Access Compliance Report

Public Rights-of-Way

(Curb Ramps)

Intersection ID: 10021099	Main Street: BEVERLY_CREST_BV	Cross Street: N/A	Location: NE
ADA ID: 6F9D53695DB0	Ramp Type: BlendTrans1	Initial Pass/Fail: Fail	Overall Compliance: No
Codes/Mitigation Info/Possible Solution			Severity Score: 25
Field Measurements/Component Compliance

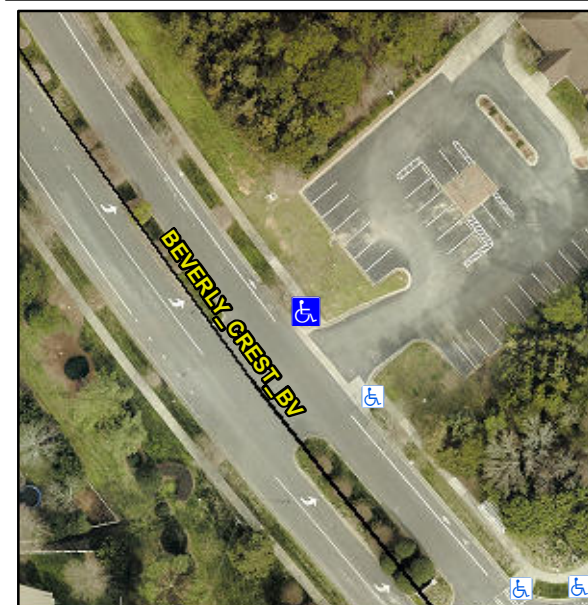
Compliance	Description	Data	Compliance	Description	Data
N/A	Ramp Length (in)	48.0	Yes	BlendTrans Slope (%)	2.3
Yes	Ramp Width (in)	48.0	No	BlendTrans XSlope (%)	12.8
N/A	Flare Type LT	N/A	N/A	Flare Type RT	N/A
N/A	Flare Slope LT (%)	N/A	N/A	Flare Slope RT (%)	N/A
N/A	Flare Traversable LT?	N/A	N/A	Flare Traversable RT?	N/A
N/A	Landing Length (in)	N/A	N/A	DWS Provided?	N/A
N/A	Landing Width (in)	N/A	N/A	DWS Contrast?	N/A
N/A	Landing Slope (%)	N/A	N/A	DWS Length (in)	N/A
N/A	Landing X Slope (%)	N/A	N/A	DWS Full Width?	N/A
N/A	Landing Curb? (Y/N)	N/A	N/A	DWS Offset (in)	N/A
N/A	Shared Landing?	N/A			
N/A	Gutter Ponding?	N/A	N/A	Gutter Slope (%)	N/A
N/A	Gutter Lip Ht (in)	N/A	N/A	Gutter X Slope (%)	N/A
N/A	Painted X Walk1?	No	N/A	Painted X Walk2?	No
	X Walk 1 Direction	To SW		X Walk 2 Direction	To SE
	X Walk 1 Width (in)	N/A		X Walk 2 Width (in)	N/A
	X Walk 1 Slope (%)	3.8		X Walk 2 Slope (%)	4.5
	X Walk 1 X Slope (%)	5.5		X Walk 2 X Slope (%)	6.0

N/A	Ramp inside XWalk1?	N/A	N/A	Ramp inside XWalk2?	N/A
	Road Slope (%)	11.1		Clear Space?	N/A
	Road X Slope (%)	0.3	N/A	Clear Space to XWalk (in)	N/A
N/A	Any Obstructions?	N/A	N/A	Storm Grate/Utility Hazard?	N/A
	Obstruction Type			Storm Grate/Utility Type	
		N/A			N/A
			Yes	Surface Condition? (G/P)	Good
			N/A	Curb Slope (%)	5.0

Remove & Replace Curb Ramp With Two New Directional Ramps or Equivalent.
